ADDENDUM NO. 4
WL-100 AREA ELEVATED STORAGE TANK PROJECT
NORTHWESTERN WATER AND SEWER DISTRICT
DECEMBER 18, 2020

PROPOSED LEMAYNE ROAD ELEVATED TANK NORTHWESTERN WATER & SEWER DISTRICT

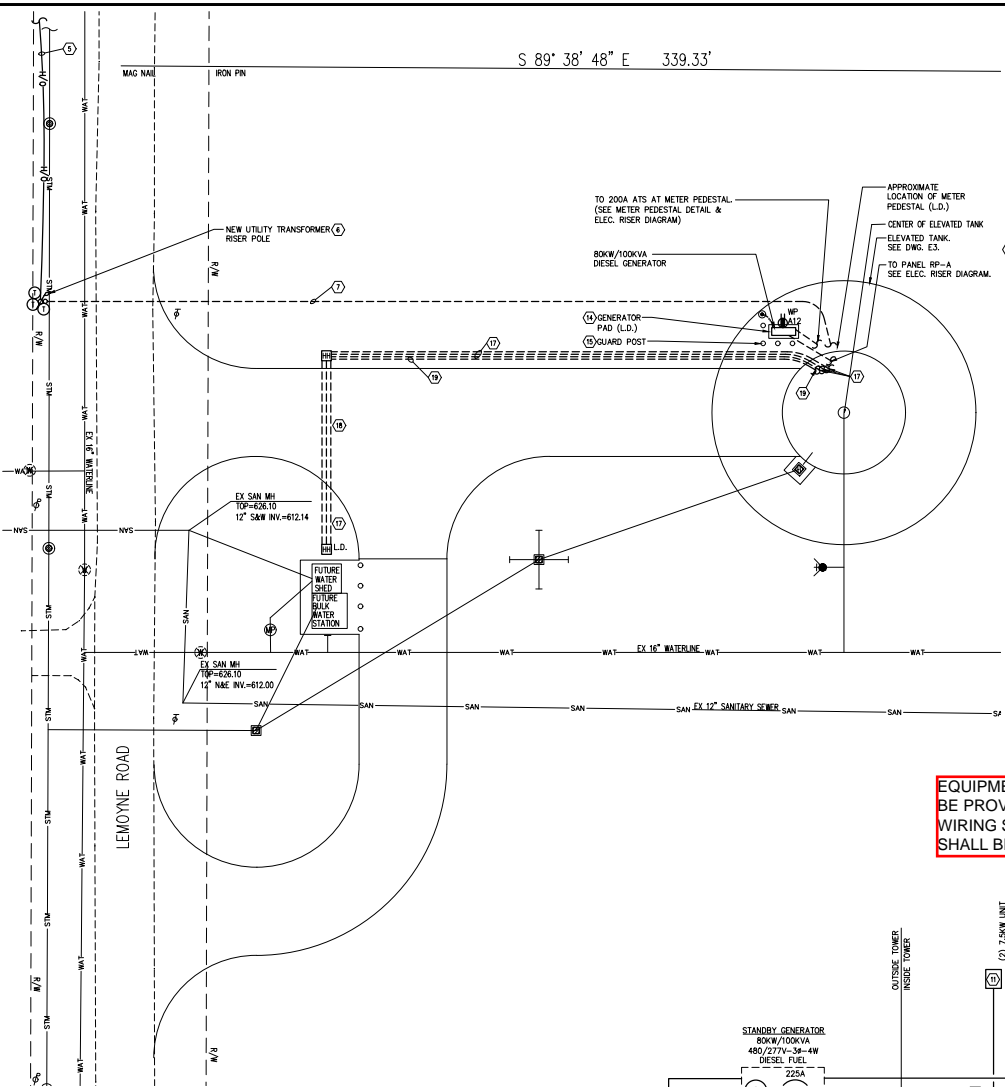
2. PLAN SHEET E3 (SEE REVISED SHEET ATTACHED)
 - a. The following items of equipment shall be provided and installed by owner. Conduit and wiring shall be provided and installed by tank contractor. This work shall be coordinated with owner and the equipment supplier. Any changes in scope and costs will be made at that time:
 - i. Ventilation System Blower and control panel
 - ii. Floating Spray Nozzle Unit and control panel
 - iii. 120 V Submersible Mixer and control panel
 - iv. Free Chlorine Analyzer
 - b. The Floating Spray Nozzle Unit Pressure Transducer and all associated conduit shall be deleted.
